Access Compliance Report

Public Rights-of-Way

(Curb Ramps)

Intersection ID: 48941	Main Street: PEPPERPIKE_WY	Cross Street: MORGAN_LEE_AV	Location: NW
ADA ID: 738CCACFE002	Ramp Type: Perp	Initial Pass/Fail: Fail	Overall Compliance: No
Severity Score: 1.25			
Codes/Mitigation Info/Possible Solution		Field Measurements/Component Compliance

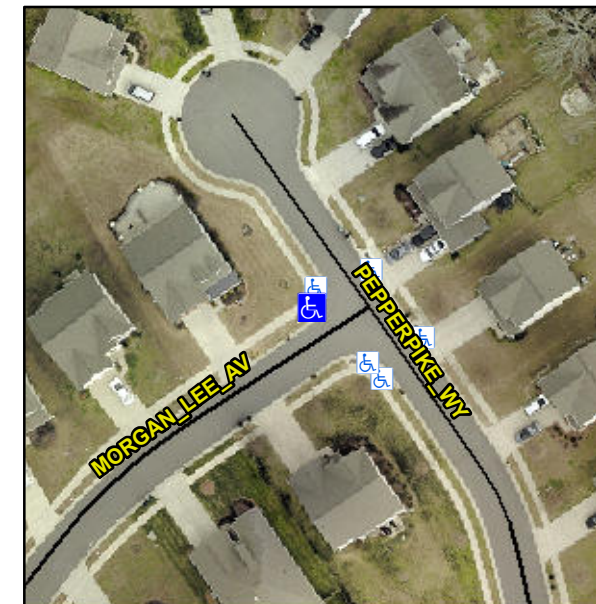
Not Found, R304.5.3

Compliance	Description	Data	Compliance	Description	Data
N/A	Ramp Length (in)	56.0	Yes	Ramp Slope (%)	6.5
Yes	Ramp Width (in)	48.0	No	Ramp XSlope (%)	2.9
N/A	Flare Type LT	N/A	N/A	Flare Type RT	N/A
N/A	Flare Slope LT (%)	N/A	N/A	Flare Slope RT (%)	N/A
N/A	Flare Traversable LT?	N/A	N/A	Flare Traversable RT?	N/A
N/A	Landing Length (in)	N/A	N/A	DWS Provided?	N/A
N/A	Landing Width (in)	N/A	N/A	DWS Contrast?	N/A
N/A	Landing Slope (%)	N/A	N/A	DWS Length (in)	N/A
N/A	Landing X Slope (%)	N/A	N/A	DWS Full Width?	N/A
N/A	Landing Curb? (Y/N)	N/A	N/A	DWS Offset (in)	N/A
N/A	Shared Landing?	N/A			
N/A	Gutter Ponding?	N/A	N/A	Gutter Slope (%)	N/A
N/A	Gutter Lip Ht (in)	N/A	N/A	Gutter X Slope (%)	N/A
N/A	Painted X Walk1?	No	N/A	Painted X Walk2?	N/A
	X Walk 1 Direction	To SW		X Walk 2 Direction	N/A
N/A	X Walk 1 Width (in)	N/A	N/A	X Walk 2 Width (in)	N/A
	X Walk 1 Slope (%)	0.3		X Walk 2 Slope (%)	N/A
	X Walk 1 X Slope (%)	2.1		X Walk 2 X Slope (%)	N/A

Remove & Replace Entire Ramp.
